ADDENDUM NUMBER TWO (2)

**2018 BOND PROJECT: RESTROOM IMPROVEMENTS FOR
LANIER HIGH SCHOOL**

JACKSON PUBLIC SCHOOL DISTRICT
JACKSON, MISSISSIPPI

January 17, 2020

1 ENLARGED PLAN - BASE BID
A101R 1/4" = 1'-0"

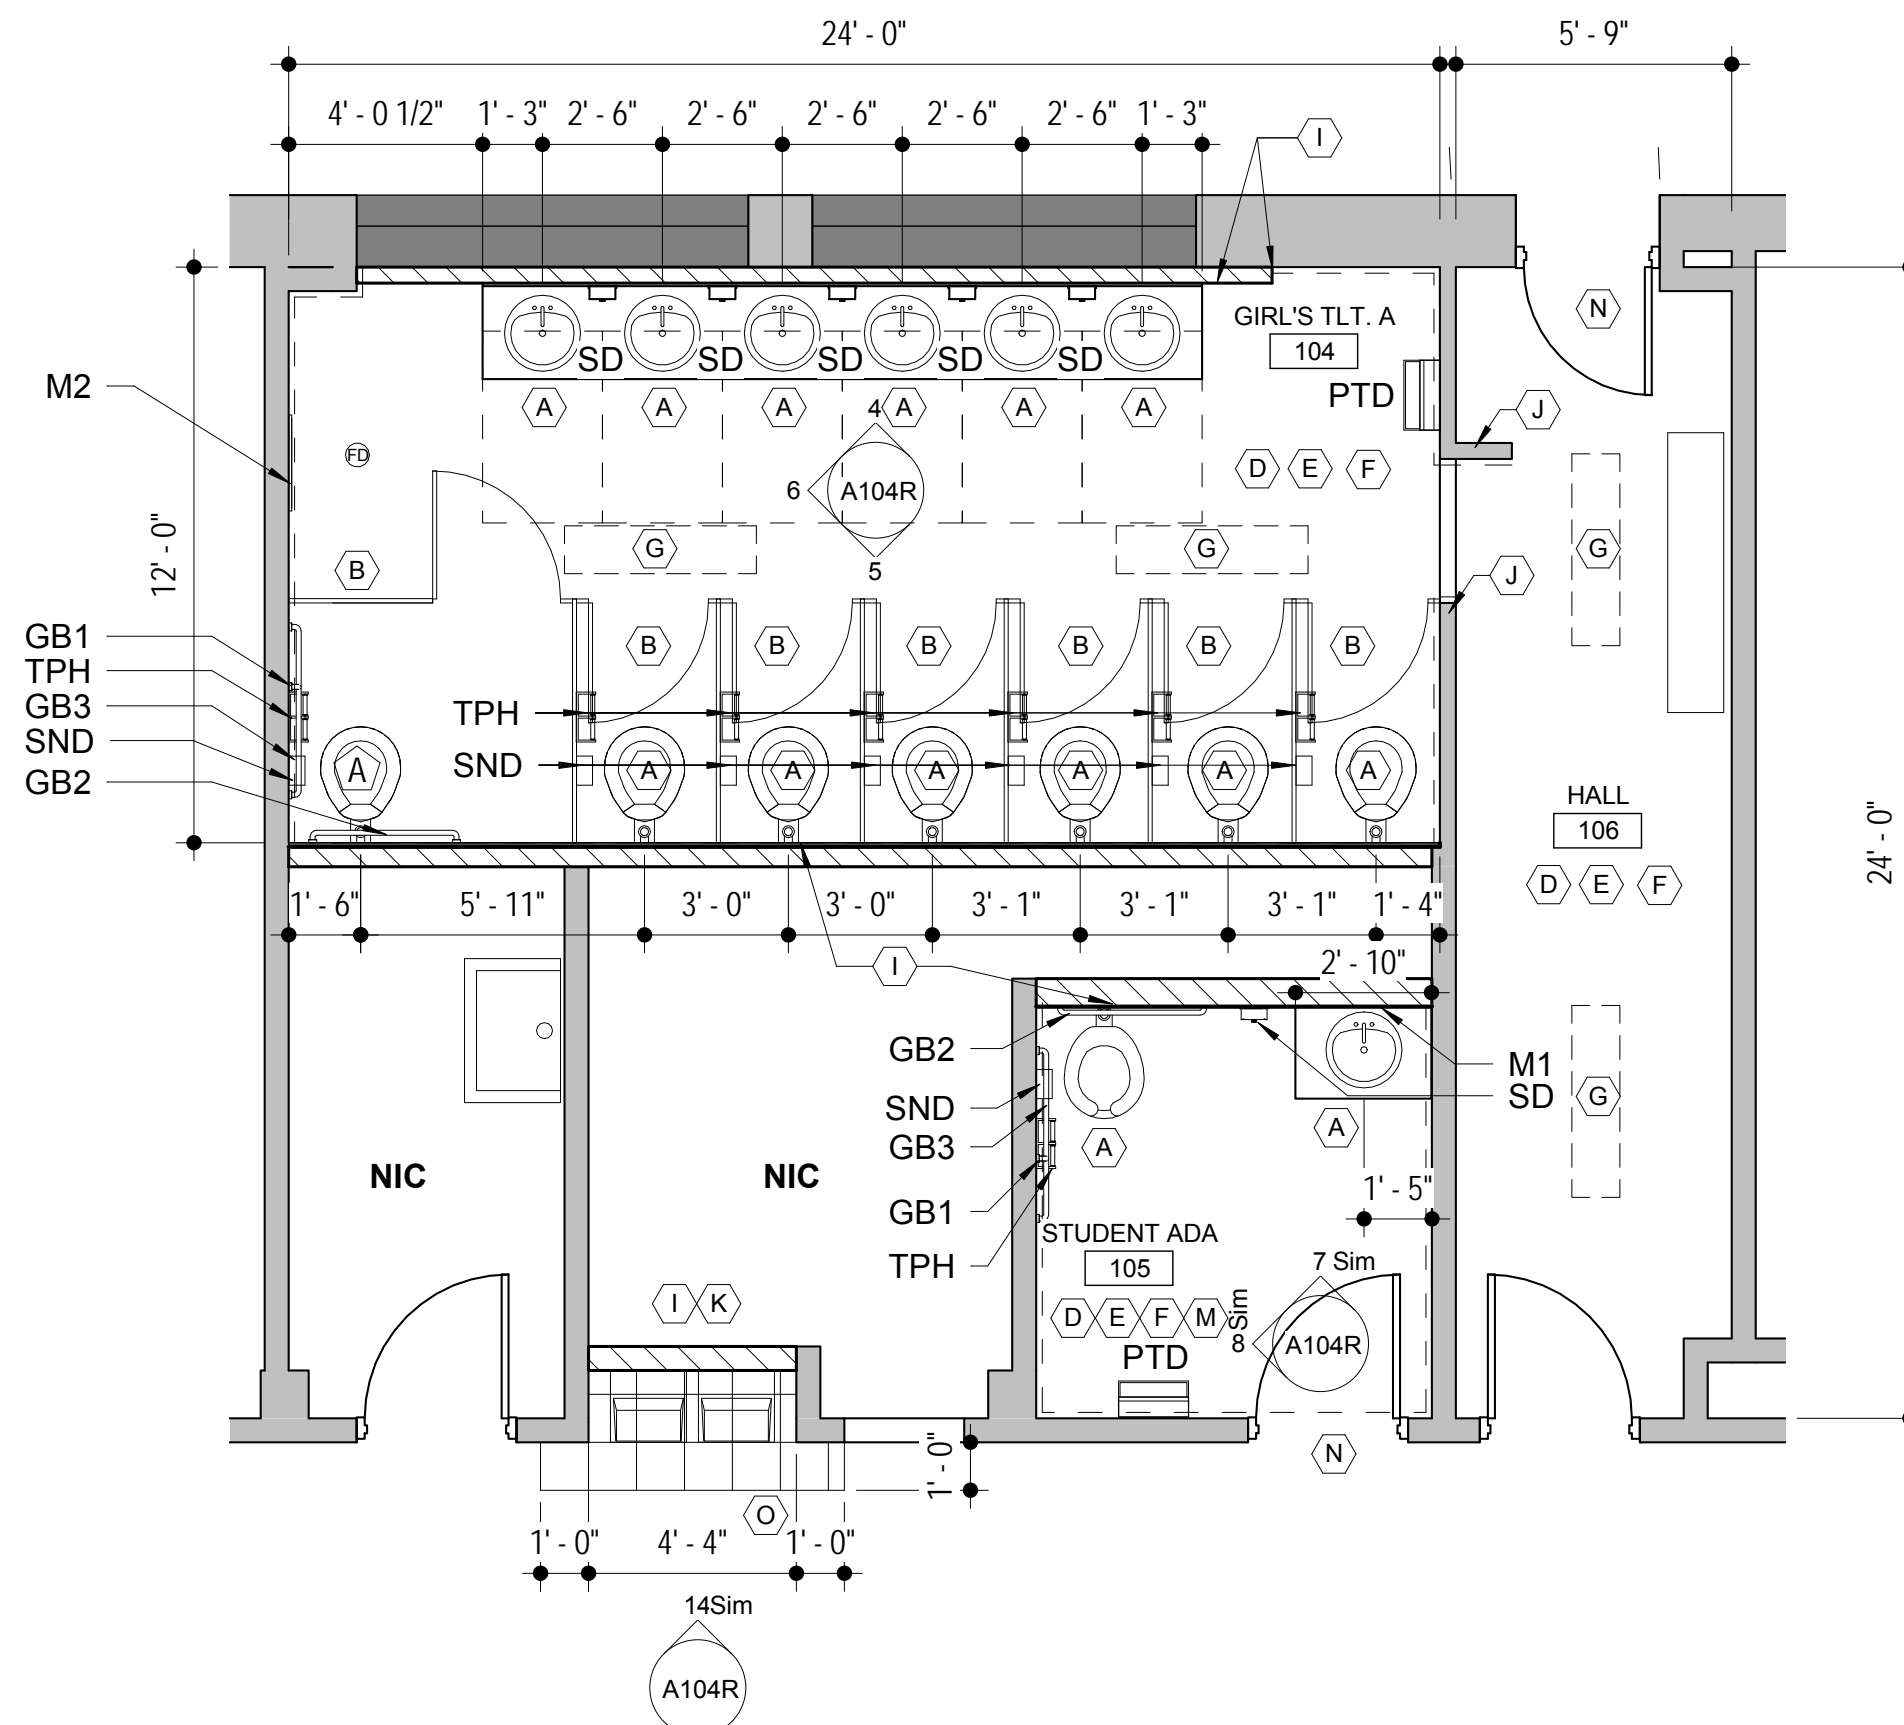
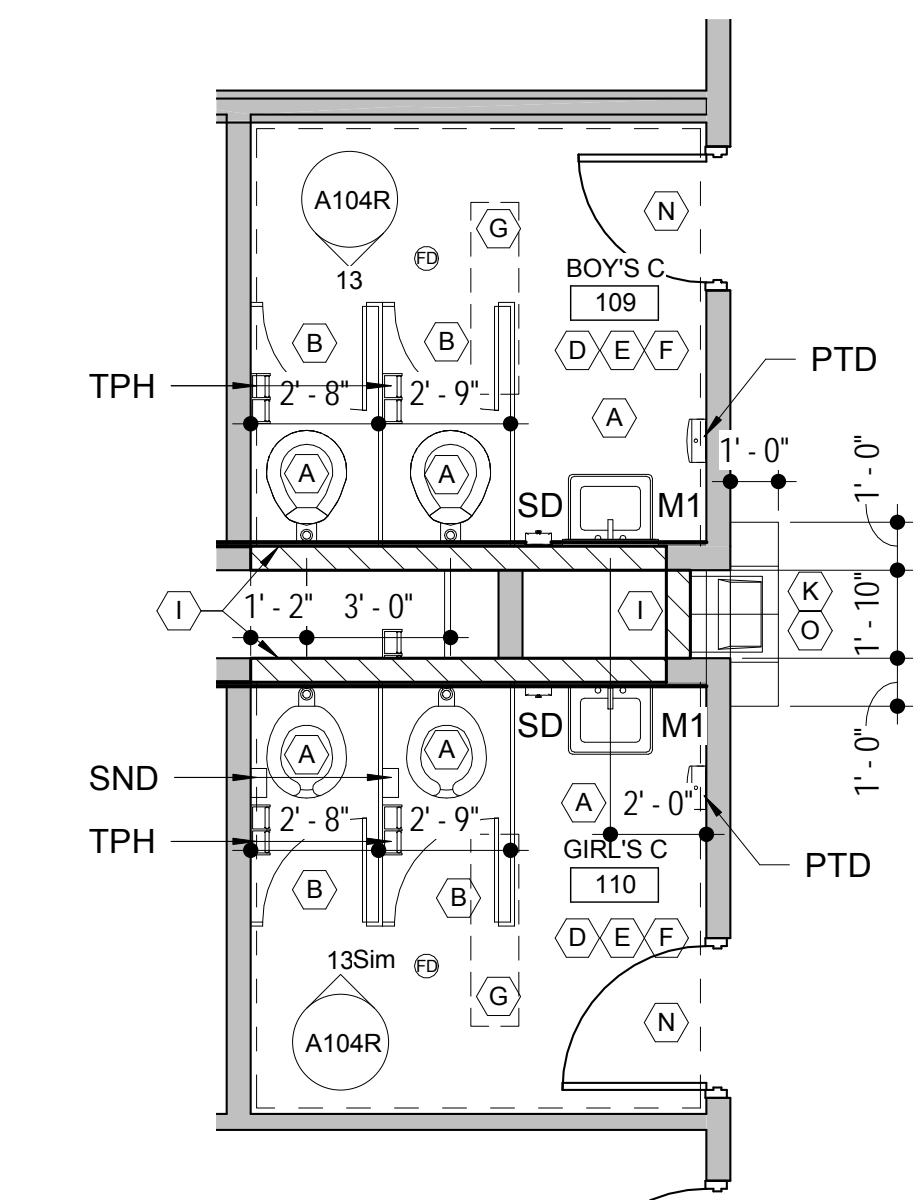
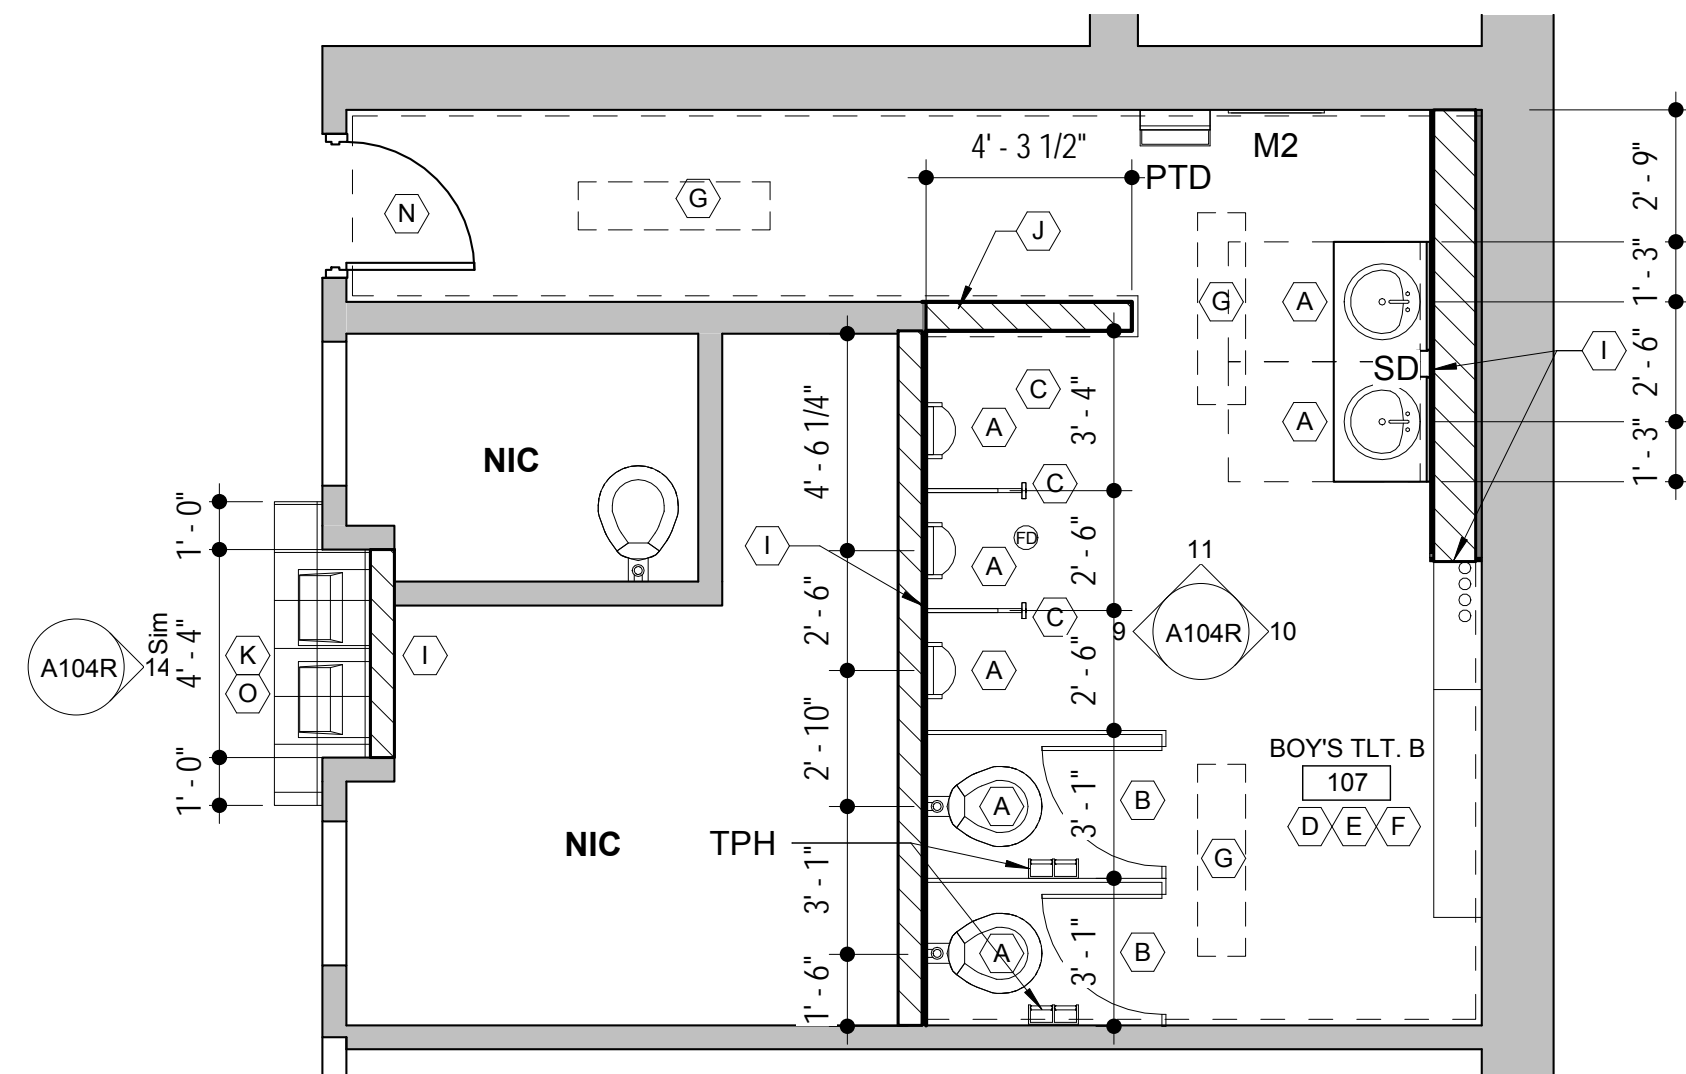
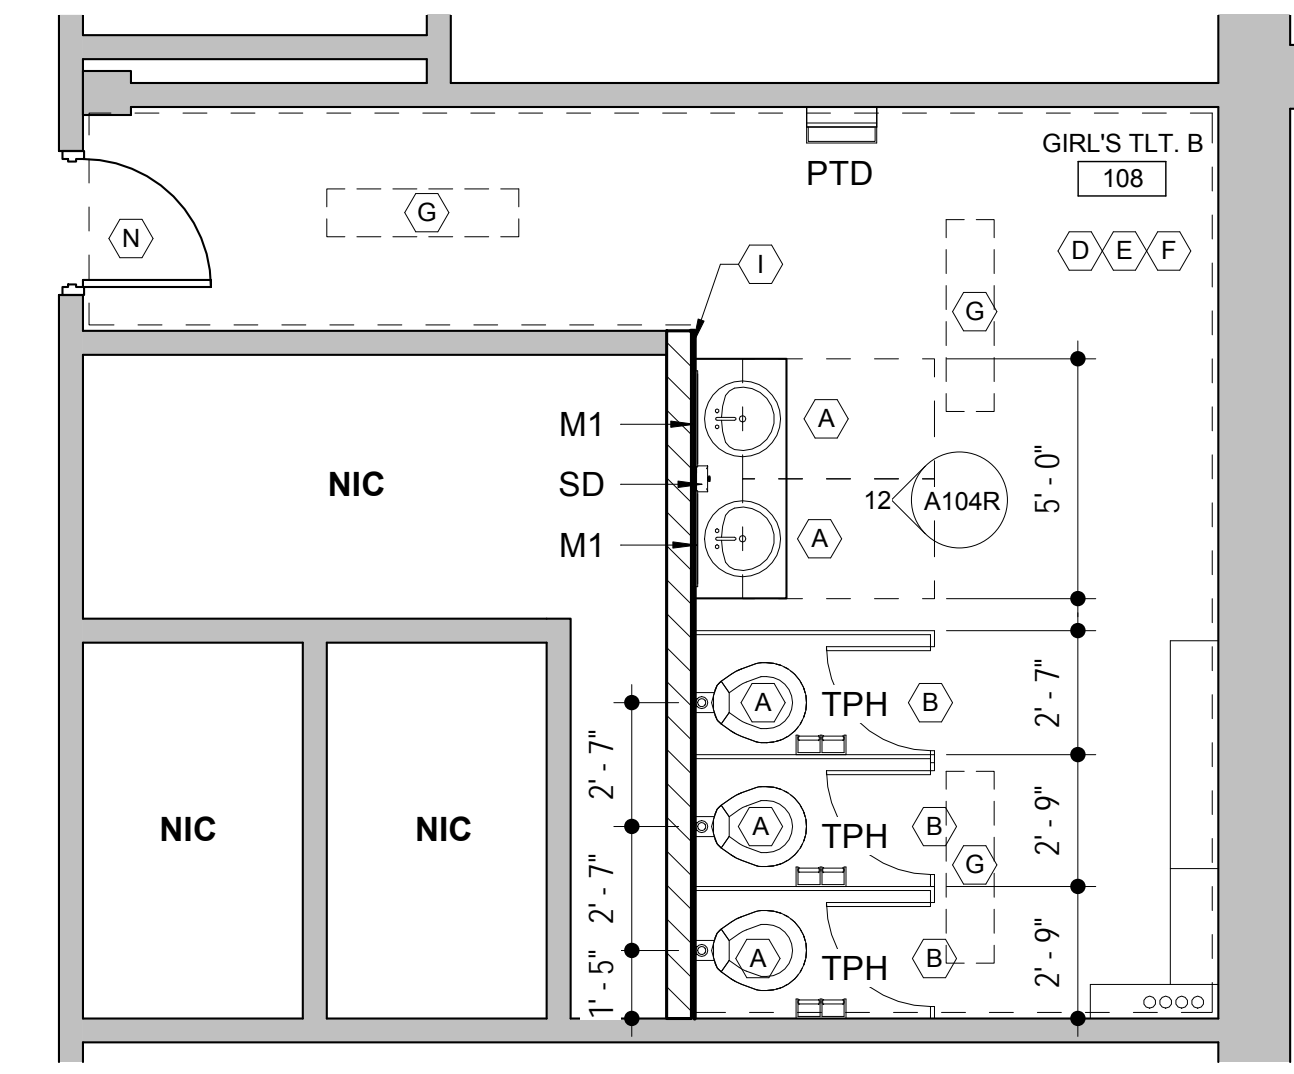
Item 20: SHEET A101 – ENLARGED NEW PLANS

DELETE Drawing A101 in its entirety and **REPLACE** with attached A101R.

TAG	MFG	TYPE (DESCRIPTION)	MFG#
TPH	BOBRICK	TOILET PAPER HOLDER	B-2740
GB-1	BOBRICK	GRAB BAR - 18" LONG	B-6806.99X18
GB-2	BOBRICK	GRAB BAR - 36" LONG	B-6806.99X36
GB-3	BOBRICK	GRAB BAR - 42" LONG	B-6806.99X42
M1	BOBRICK	MIRROR - 24" X 36"	B-169
M2	BOBRICK	MIRROR - 24" X 72"	B-169
PTD	BOBRICK	PAPER TOWEL DISPENSER/WASTE RECEPTACLE	B-262
SD	BOBRICK	SOAP DISPENSER	B-2112
SND	BOBRICK	SANITARY NAPKIN DISPOSAL	B-270

1 EXISTING - 1ST FLOOR (PLUMBING)
 P101 1" = 20'-0"

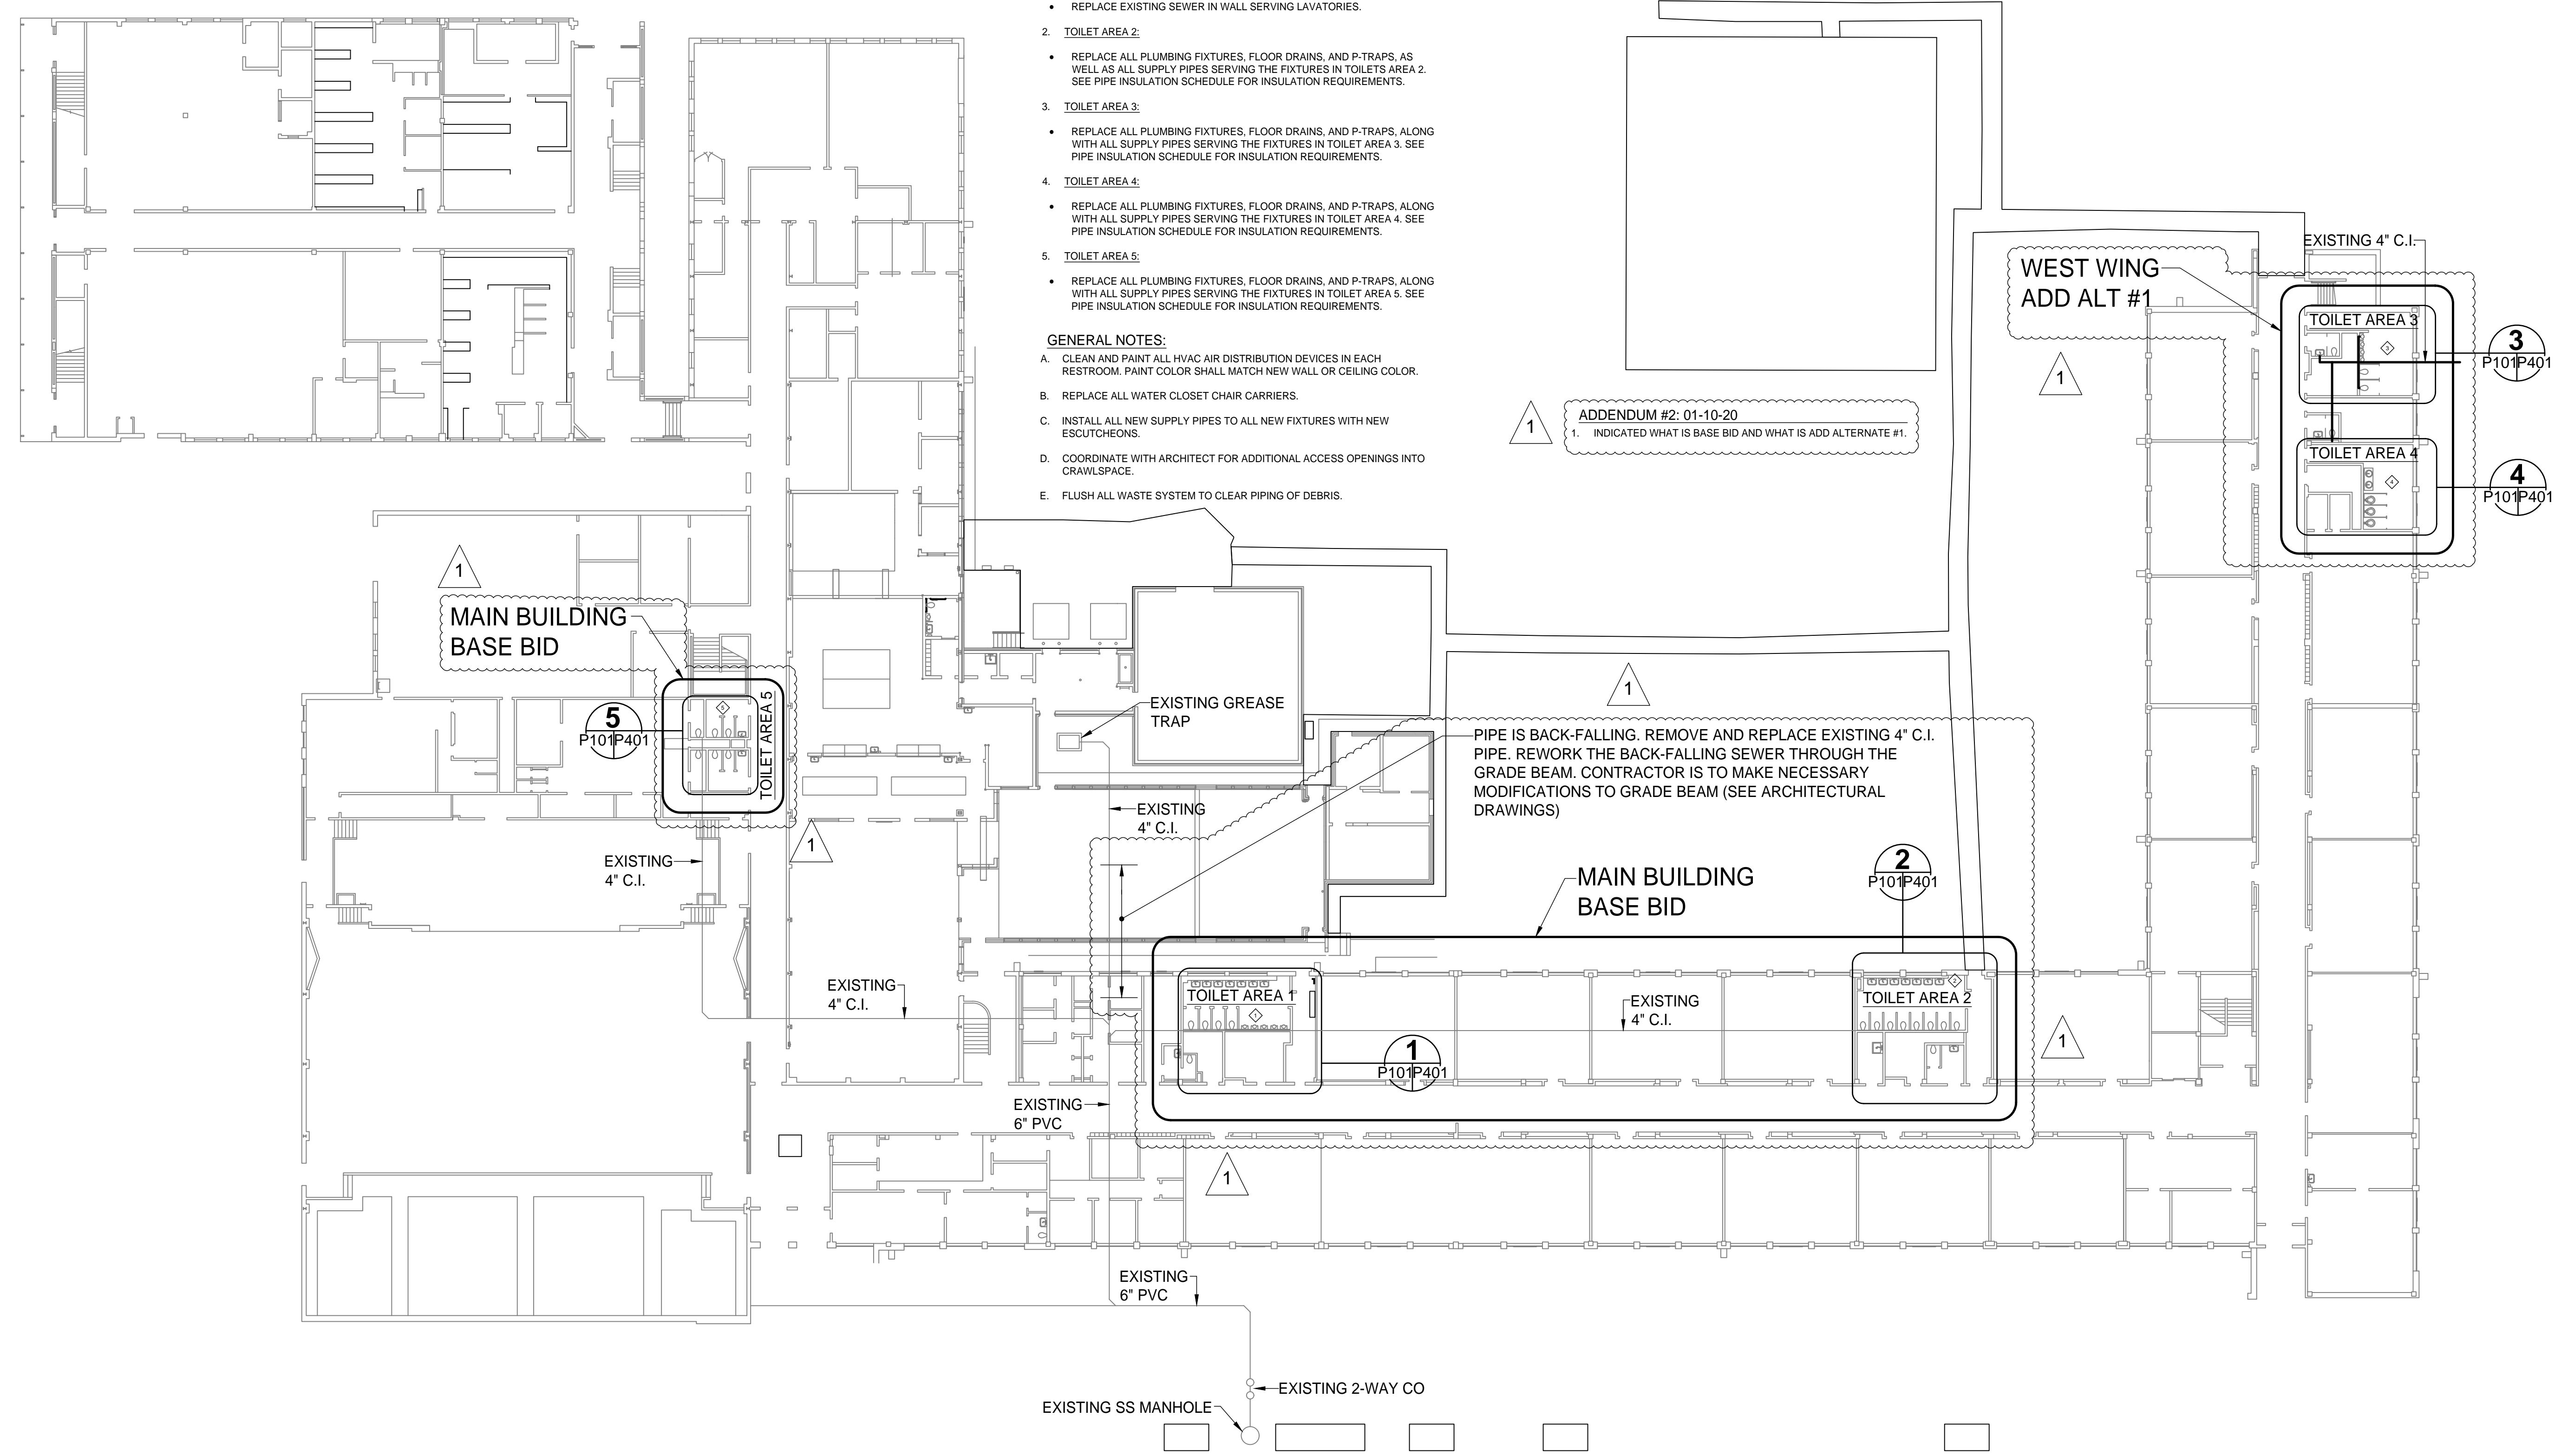
ADDENDUM #2: 01-10-20
 1. INDICATED WHAT IS BASE BID AND WHAT IS ADD ALTERNATE #1.

PIPE IS BACK-FALLING. REMOVE AND REPLACE EXISTING 4" C.I. PIPE. REWORK THE BACK-FALLING SEWER THROUGH THE GRADE BEAM. CONTRACTOR IS TO MAKE NECESSARY MODIFICATIONS TO GRADE BEAM (SEE ARCHITECTURAL DRAWINGS)
